LR-N17-0135
LAR S17-05

Salem Generating Station, Units 1 and 2
Renewed Facility Operating License Nos. DPR-70 and DPR-75
NRC Docket Nos. 50-272 and 50-311

Subject: **License Amendment Request for Implementation of WCAP-14333 and WCAP-15376, Reactor Trip System Instrumentation and Engineered Safety Feature Actuation System Instrumentation Test Times and Completion Times**

FIGURE 4-1
SA115A LOGIC WITHOUT SEMIAUTOMATIC TRANSFER TO RECIRCULATION

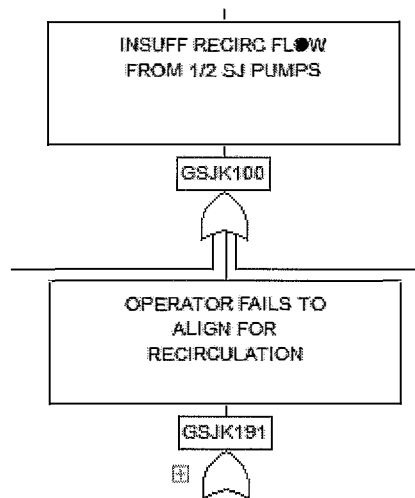
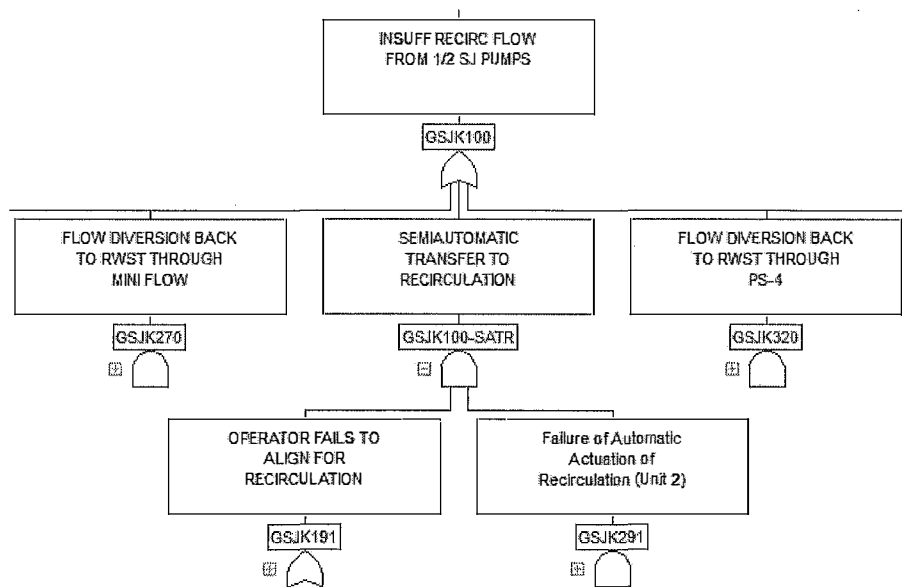
Semiautomatic transfer to recirculation capability only exists for Salem Unit 2. The Salem MOR only models Unit 1, therefore an application-specific Unit 2 model, SA215B, had to be created in order to add semiautomatic transfer to recirculation logic. This Unit 2 specific model also includes the additional UV relay testing/maintenance events discussed above.

This logic is created by inserting a level above all “Operator Fails to Align for Recirculation” gates and combining them, through use of an AND gate, with a “Failure of transfer to recirculation” gate. Figures 4-1 and 4-2 below show one example of the old logic versus the new logic.

FIGURE 4-3
FAILURE OF AUTOMATIC ACTUATION OF RECIRCULATION LOGIC IN SA215B

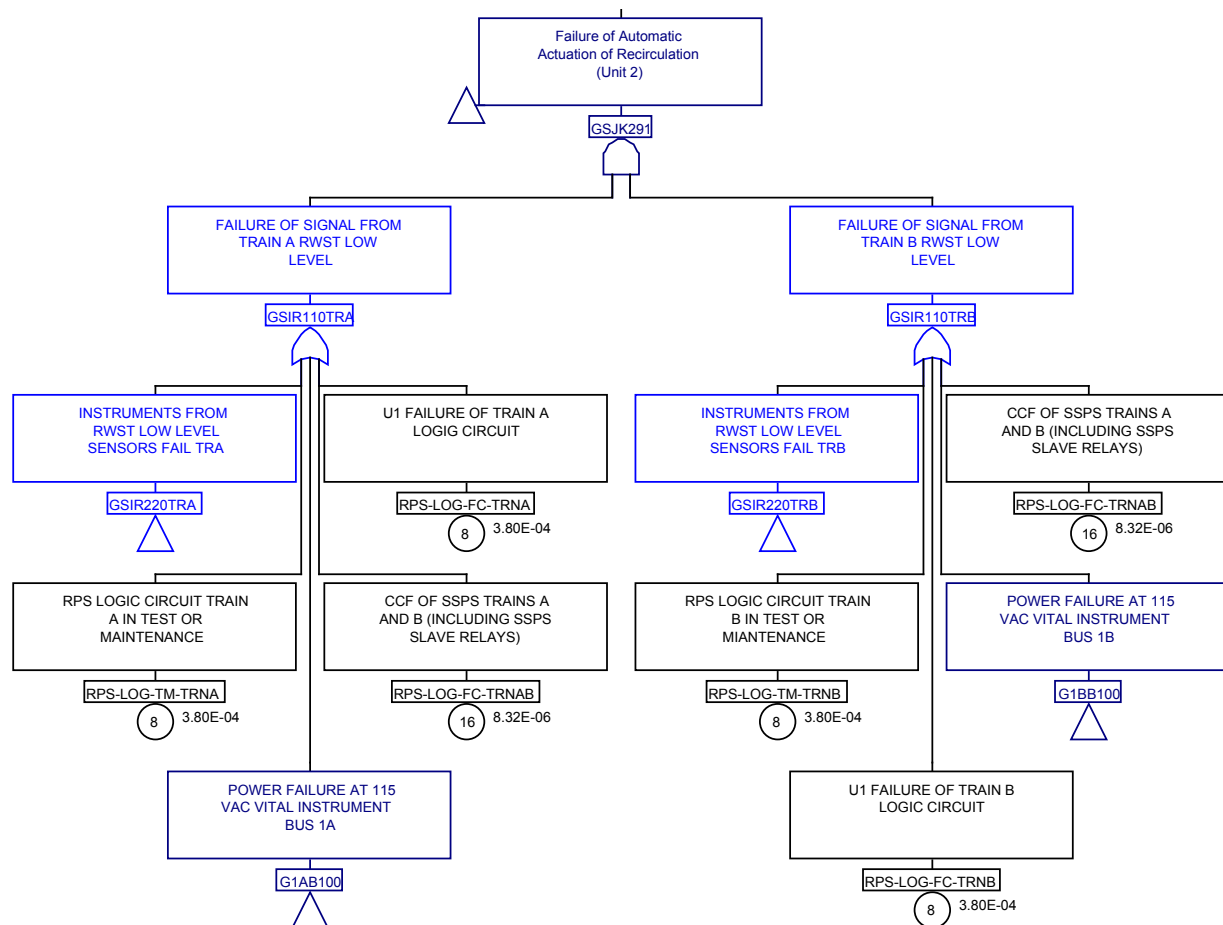
The new "Failure of Automatic Actuation of Recirculation (Unit 2)" gate requires failure of both Train A and B of the RWST low level logic. Each train then includes a power dependency, common cause failure term, logic circuit failure term, testing/maintenance term, and sensor failure gate. Each train has four RWST low level sensors of which 2 are required in order for the train to be successful [Reference 19], [Reference 20]. Several SSPS basic events are shared with other ESFAS/RTS functions. This can be seen in Figure 4-3 below.
